Dewberry Springs Subdivision

City Plan Commission — July 2, 2026

CASE NUMBER/TYPE:	SUSU26-00034 – Major Combination
CASE MANAGER:	Myrna Aguilar, (915) 212-1584, AguilarMP@elpasotexas.gov
PROPERTY OWNER:	DVEP Land, LLC
REPRESENTATIVE:	Del Rio Engineering, Inc.
LOCATION:	East of Resler Dr. and North of Transmountain Rd. (District 1)
PROPERTY AREA:	6.84 acres
VESTED RIGHTS STATUS:	Not Vested
PARK FEES:	\$60,280.00
EXCEPTIONS/MODIFICATIONS:	Yes, see following section
ZONING DISTRICT(S):	P-R II (Planned Residential District II)
RELATED APPLICATIONS:	PZRZ25-00010 – Dewberry Drive

Figure A: Proposed plat with surrounding area

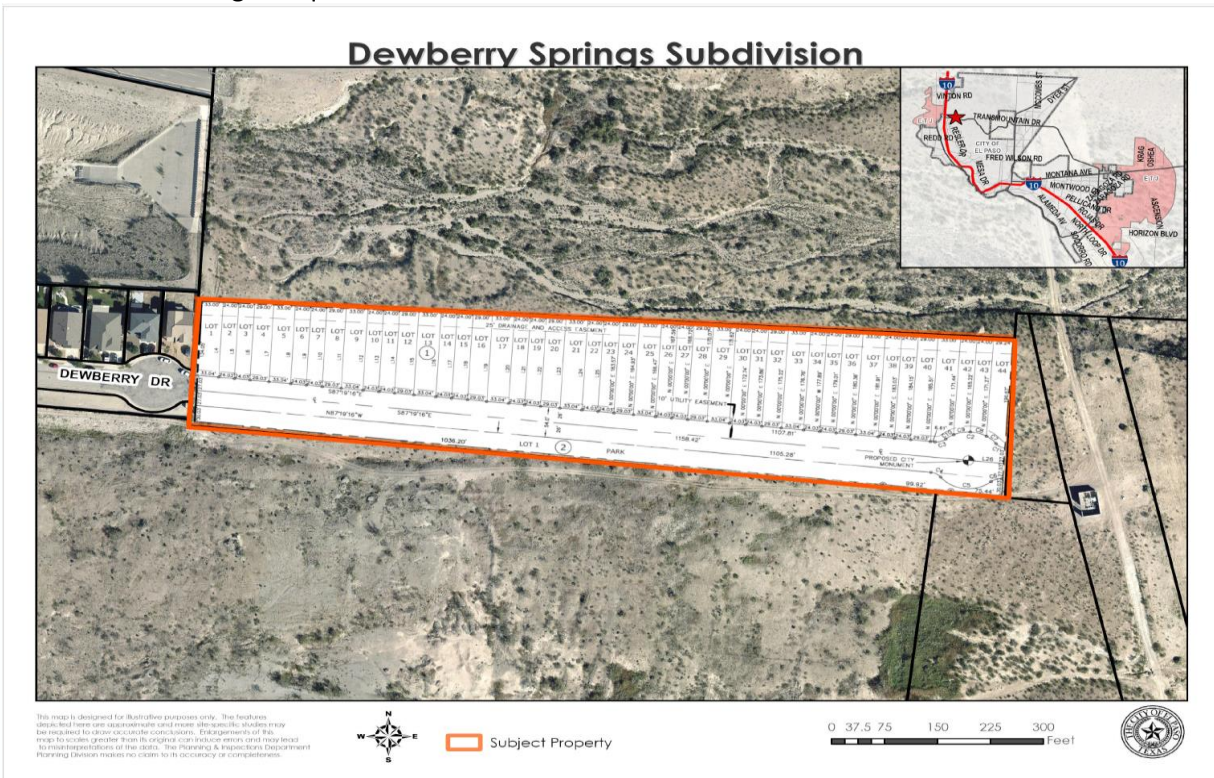
SUMMARY OF RECOMMENDATION: Staff recommends **APPROVAL WITH CONDITION** of Dewberry Springs Subdivision on a Major Combination basis and **APPROVAL** of the exception requests subject to the following condition.

- That an approved Detailed Site Development Plan be approved by the City Plan Commission prior to recordation of the final plat.

- To waive the construction of 2-feet of planter strip along both sides of Dewberry Dr.
- To waive the length requirement of 600-feet of a cul-de-sac street.
